IEEE P802.15
Wireless Personal Area Networks

Project	IEEE P802.15 Working Group for Wireless Personal Area Networks (WPANs)	
Title	MSCs Incorporating New FC SL/DME/MLME Functional Division and Imm-ACK Removal	
Date Submitted	[24 May, 2004]	
Source	[John Sarallo] [Apparent Technologies] [150 Lucius Gordon Drive, West Henrietta, NY 14586]	Voice: [585-727-2014] Fax: [585-214-2461] E-mail: [sarallo@apparent.com]
Re:	[]	
Abstract	[This document contains a list or proposed changes to IEEE Std 802.15.3.]	
Purpose	[The purpose of this document is to propose changes to IEEE Std 802.15.3 to improve compatibility, performance and clarity in the standard.]	
Notice	This document has been prepared to assist the IEEE P802.15. It is offered as a basis for discussion and is not binding on the contributing individual(s) or organization(s). The material in this document is subject to change in form and content after further study. The contributor(s) reserve(s) the right to add, amend or withdraw material contained herein.

This document presents new clause 8 MSCs resulting from Imm-ACKs no longer being used as confirmation commands as presented in 04/202r0 and with the following functional division

Figure 127 - MSC for acquiring information regarding a specific DEV or all of the DEVs from the PNC using the PNC Information Request and PNC Information commands

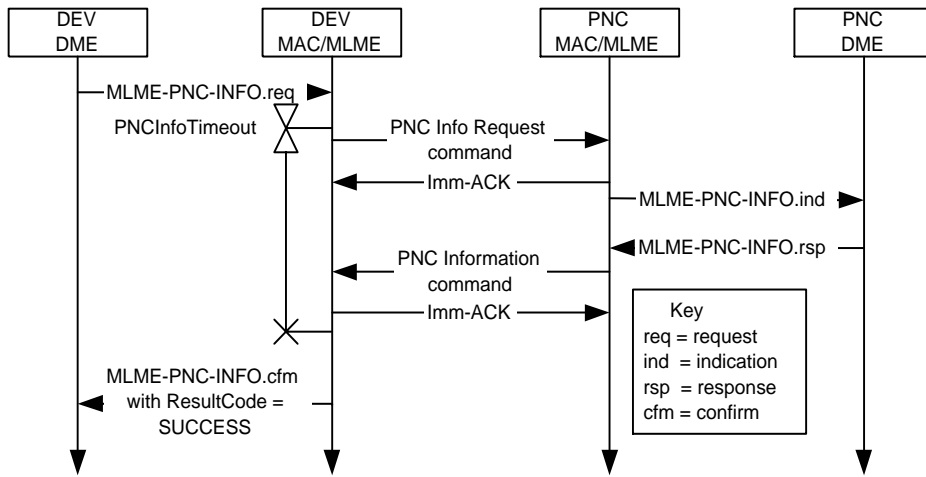
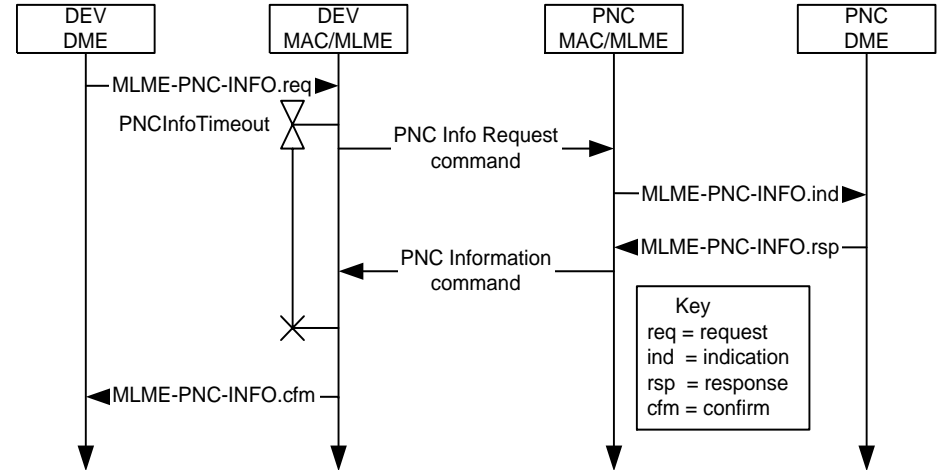
- Only change is Imm-ACKs removed.

Figure 128 - MSC for acquiring DEV IEs using the Probe Request and Probe Response commands

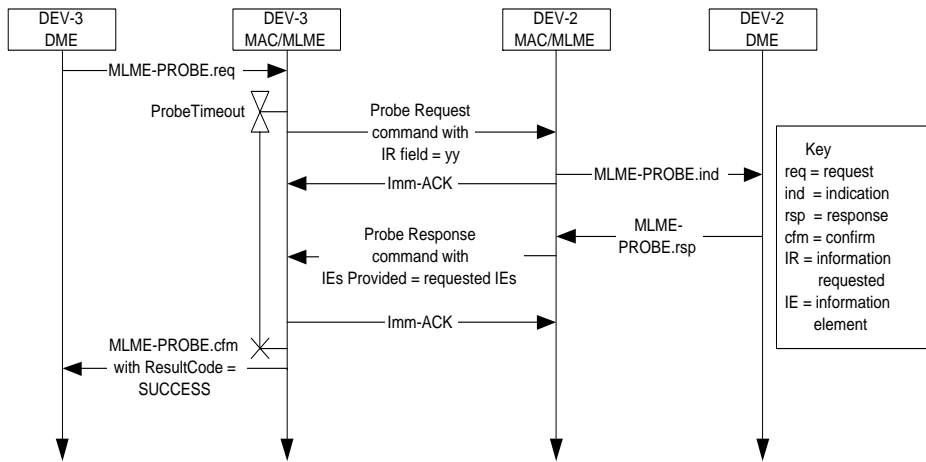
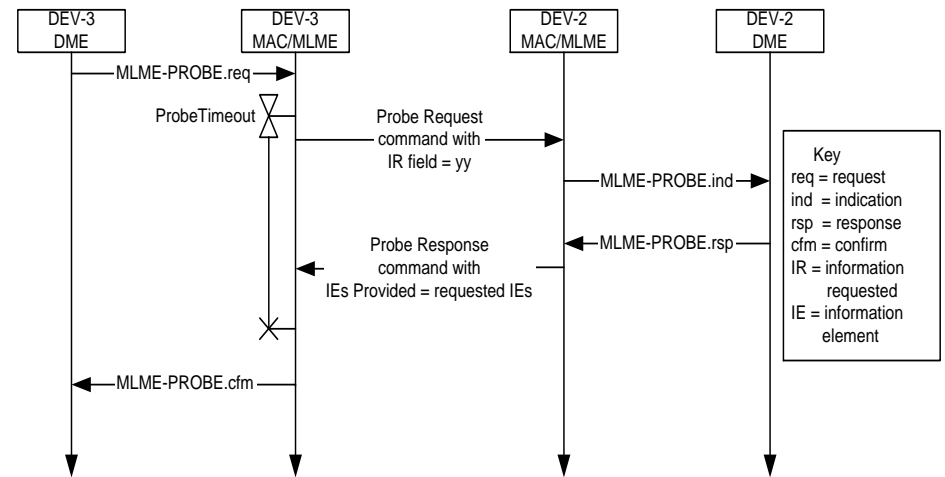
- Only change is Imm-ACKs removed.

Figure 129 - MSC showing sending of information using the Announce command

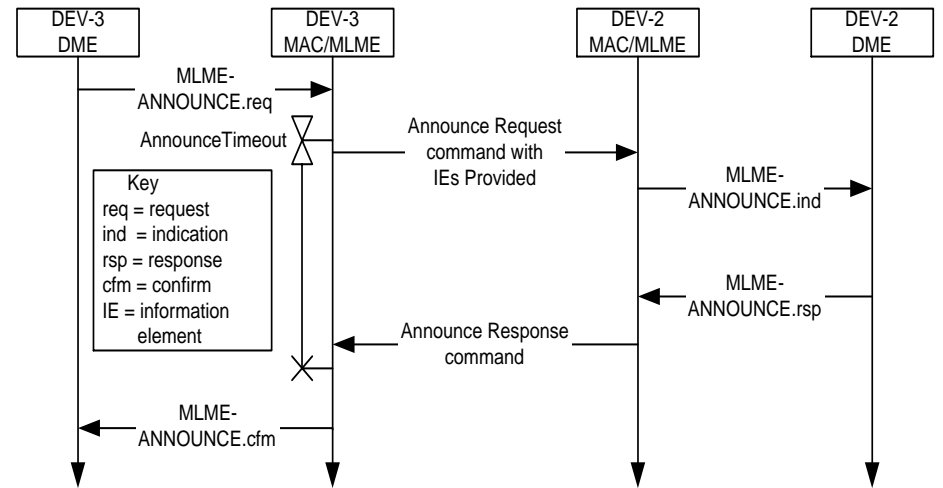
- MLME Announce Response and Announce Response command added.

Figure 130 - MSC for determining the channel status between two DEVs using the Channel Status Request and Channel Status Response commands

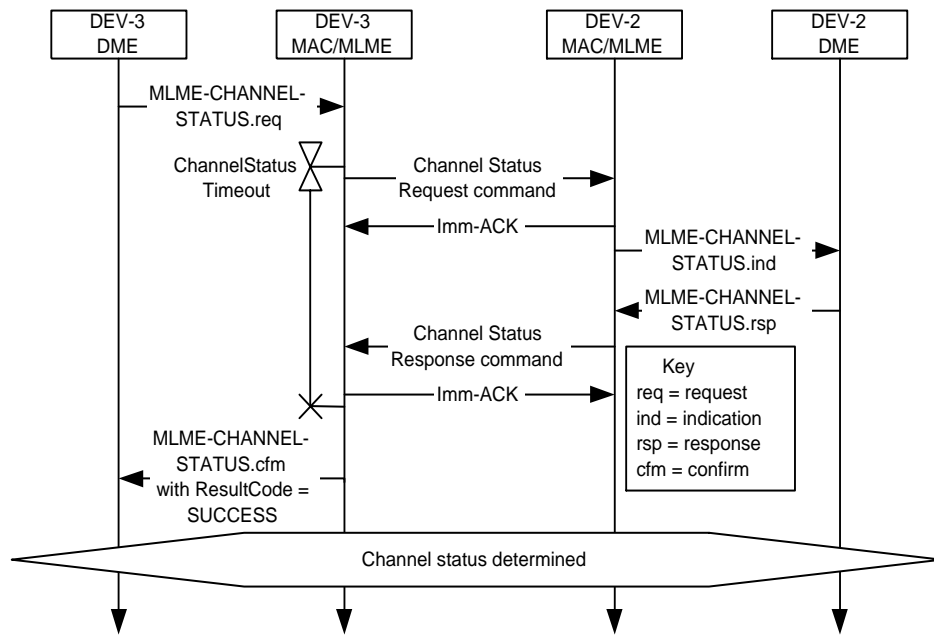
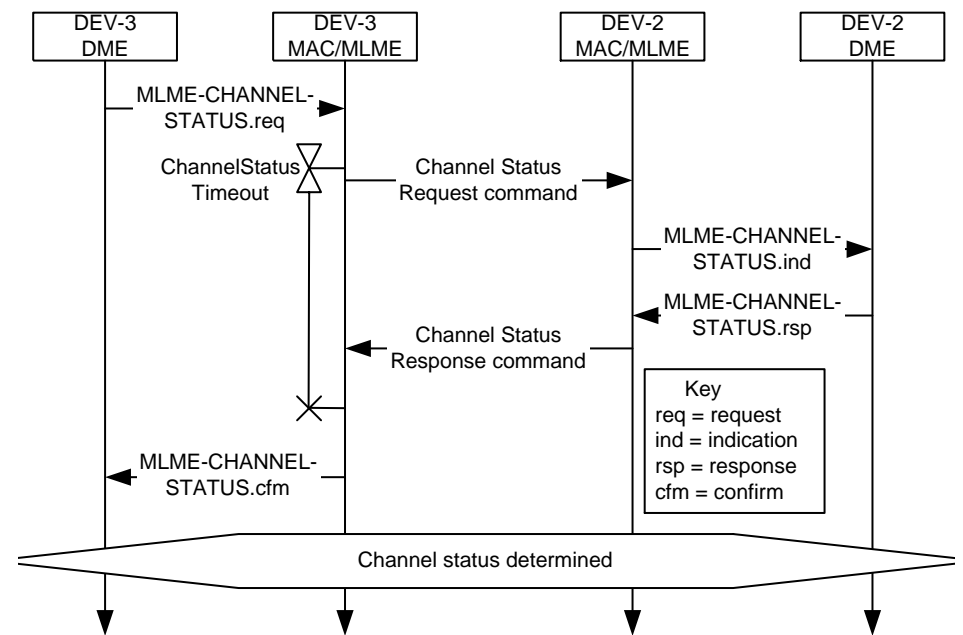
- Only change is Imm-ACKs removed.

Figure 131 - Remote scan MSC

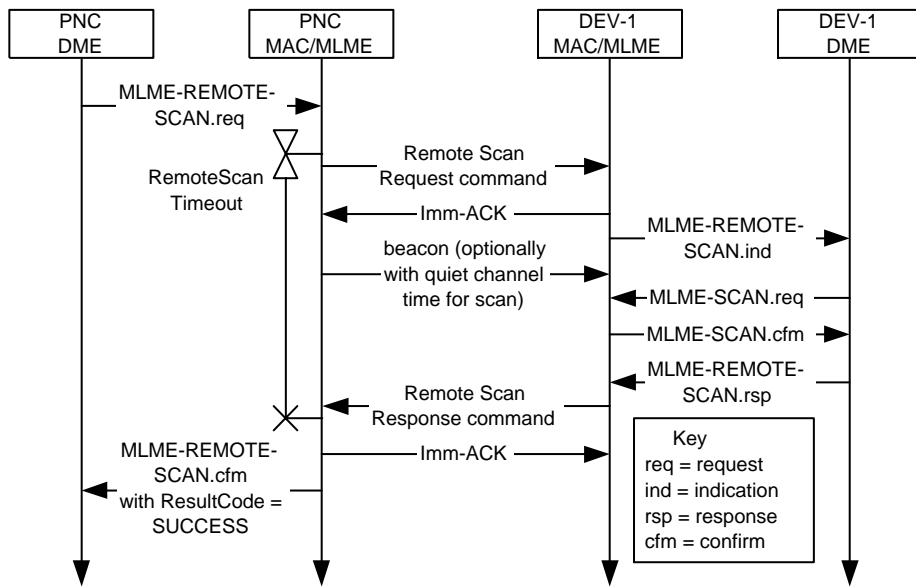
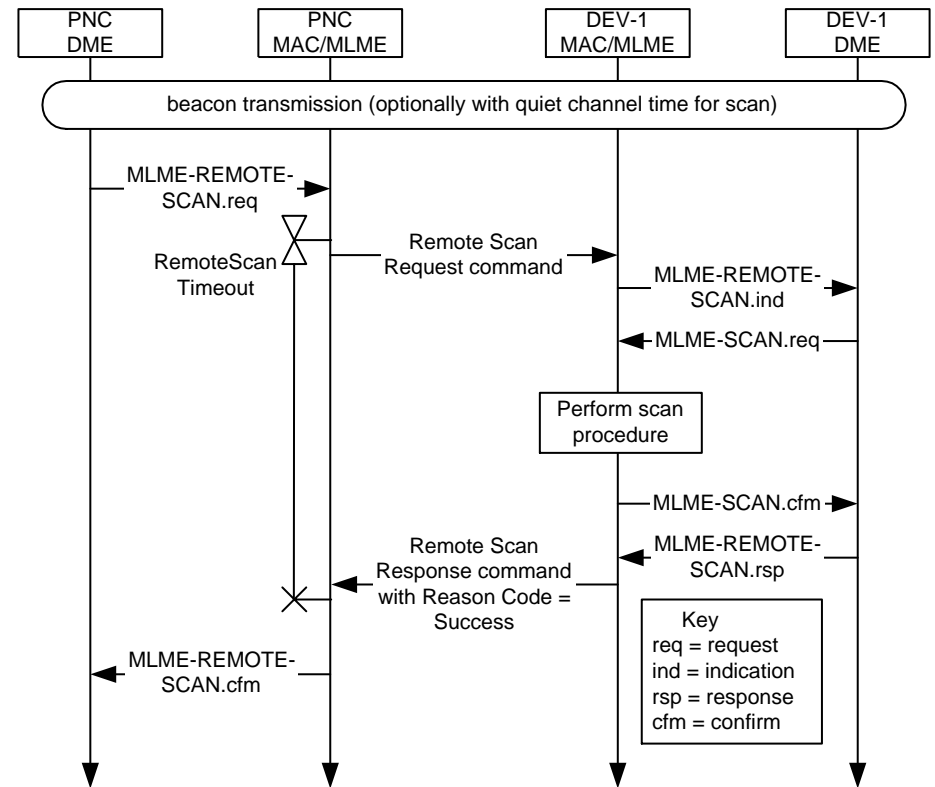
- Only real change is Imm-ACKs removed.

Figure 134 - MSC for changing either the PNID or BSID for a piconet

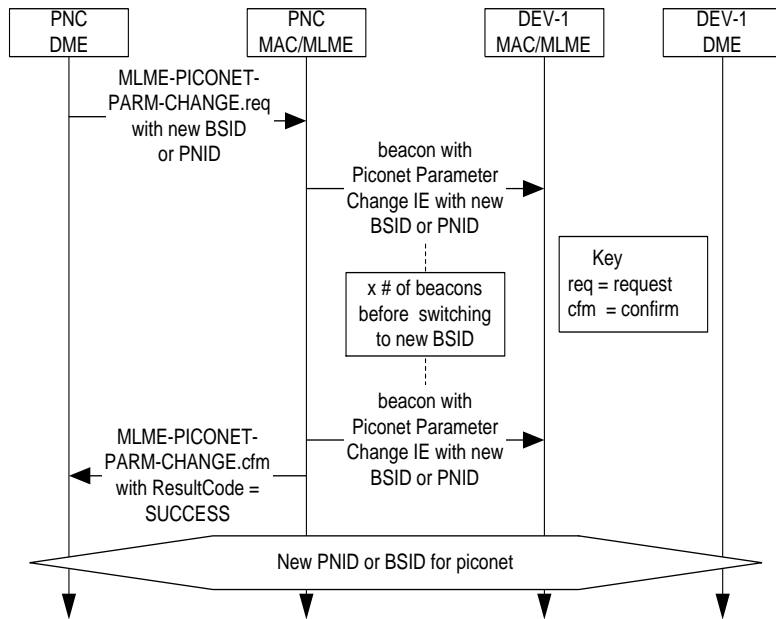
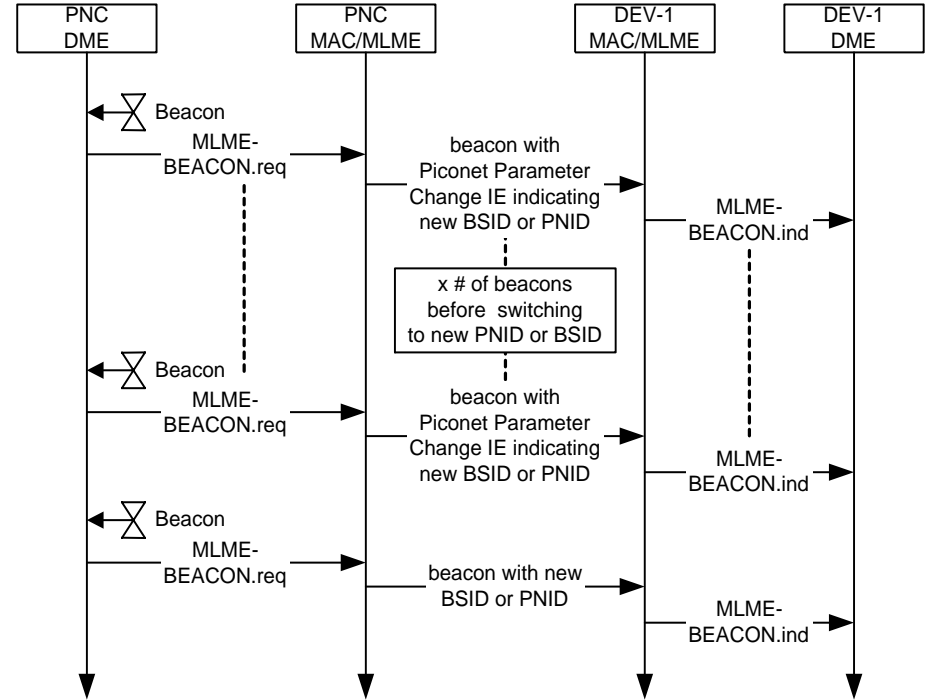
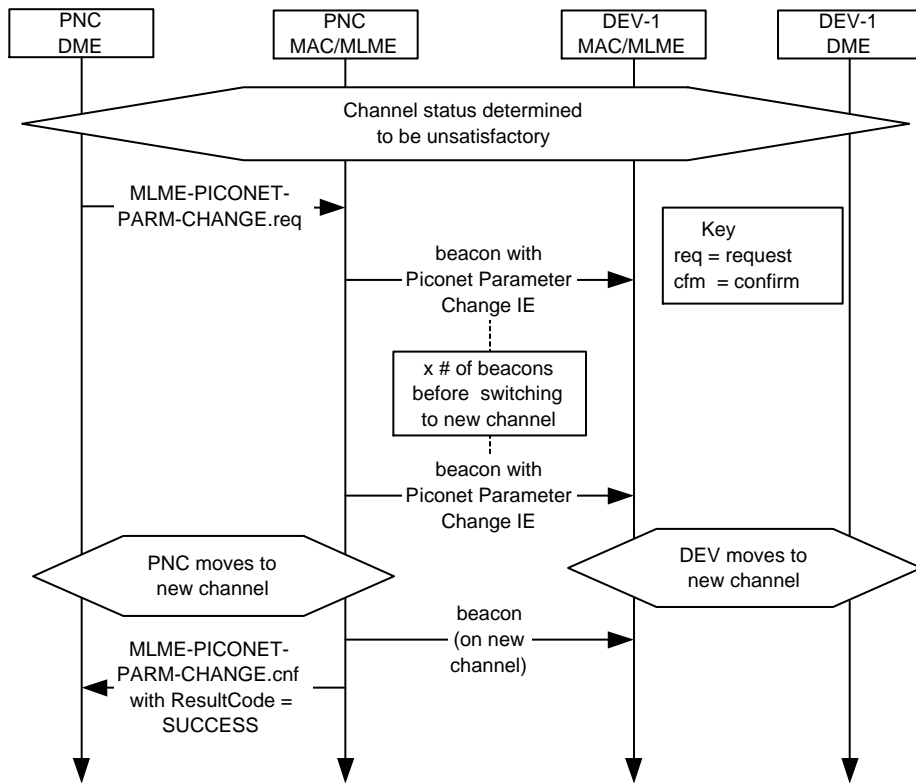
- PME is responsible for information in the beacon so the MLME-PICONET-PARM-CHANGE primitives are no longer needed.

Figure 136 - Transmit power change MSC

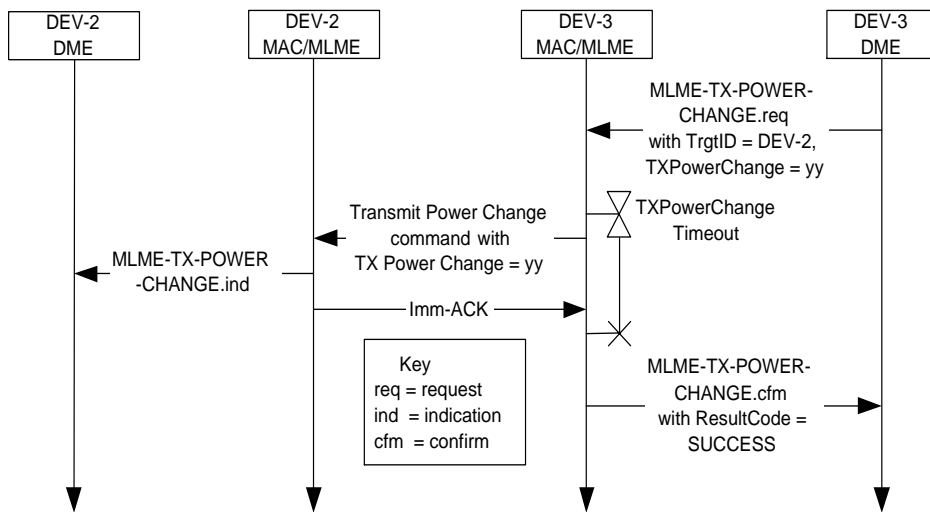
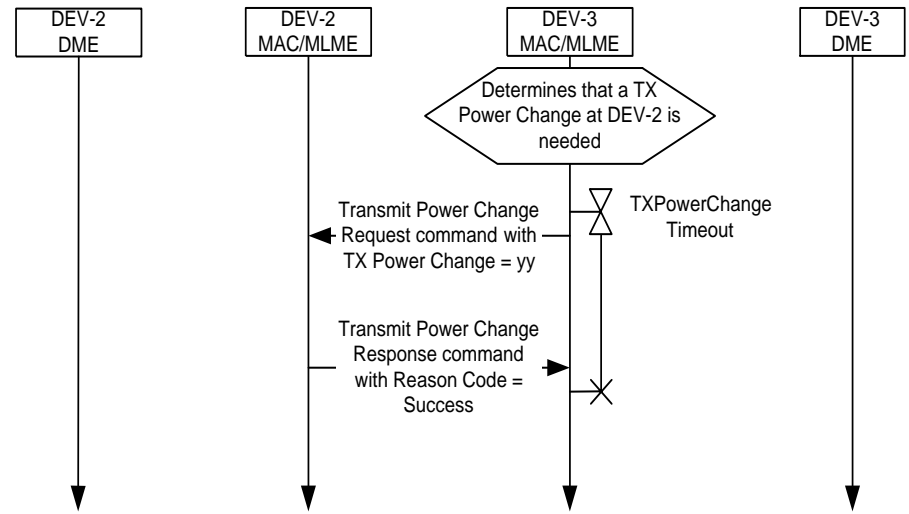
- MAC/MLME responsible for TX power adaptation, therefore MLME-TX-POWER-CHANGE primitives are no longer needed.

Figure 140 - MSC for PS set information exchange

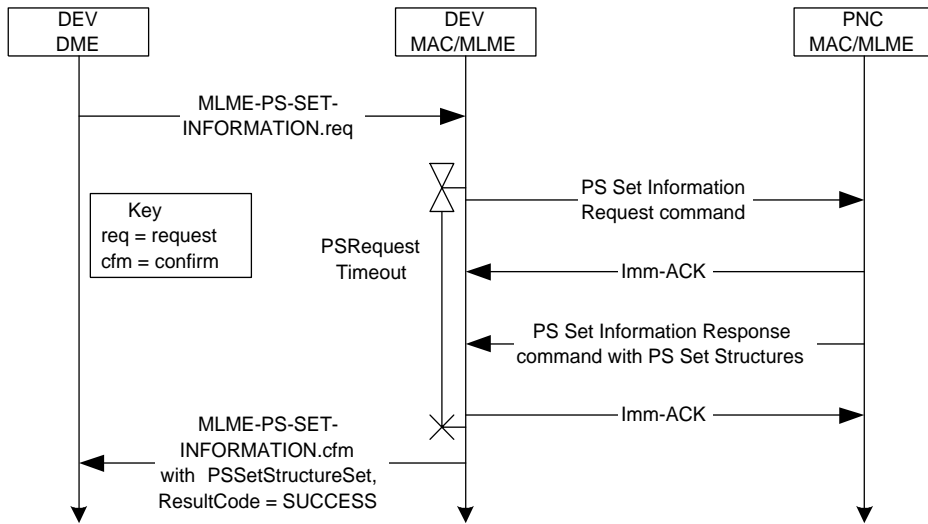
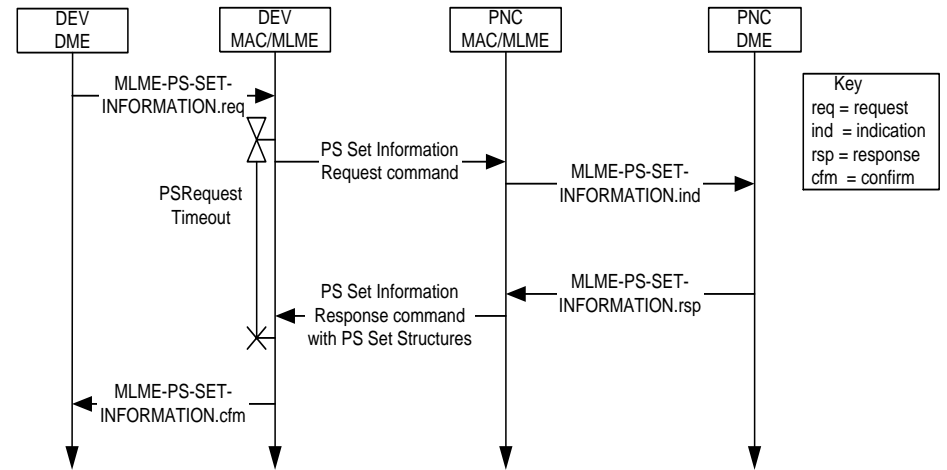
- PME is responsible for maintaining power set information, therefore, MLME-PS-SET-INFORMATION indication and response primitives are needed.

Figure 141 - MSC for DSPS set creation

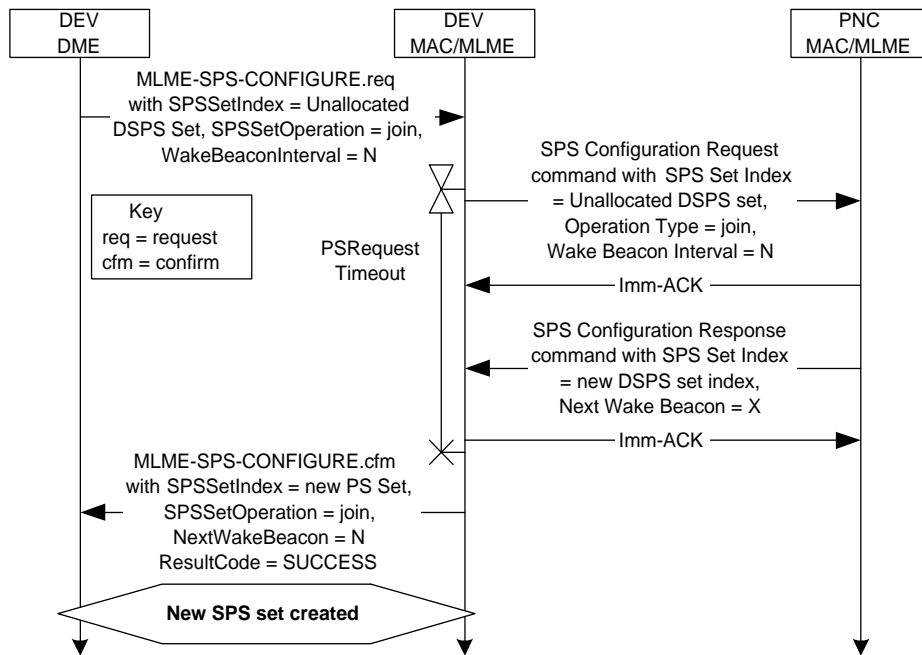
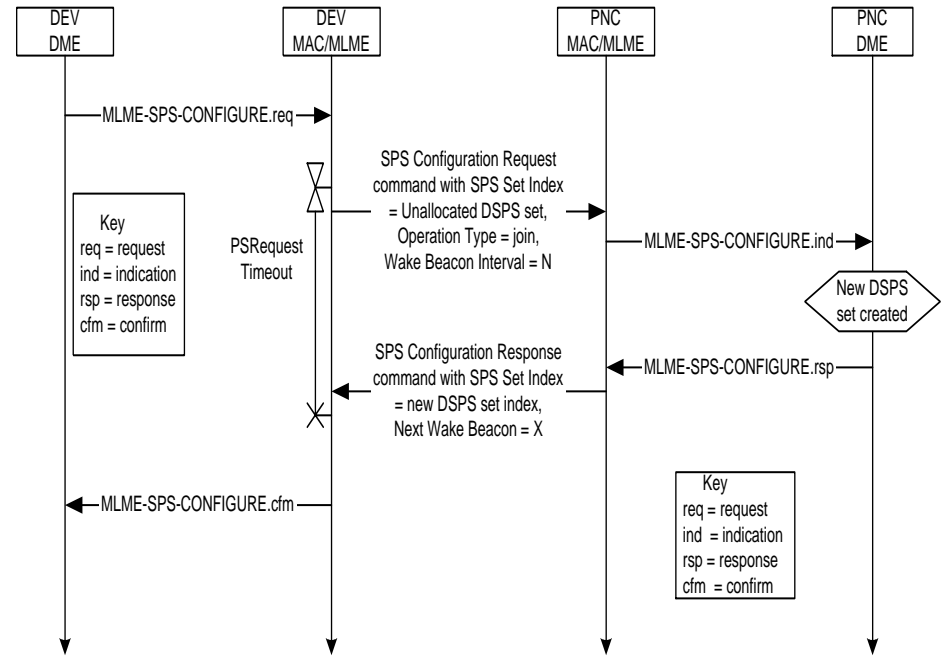
- PME is responsible for maintaining power set information, therefore, MLME-SPS-CONFIGURE indication and response primitives are needed.
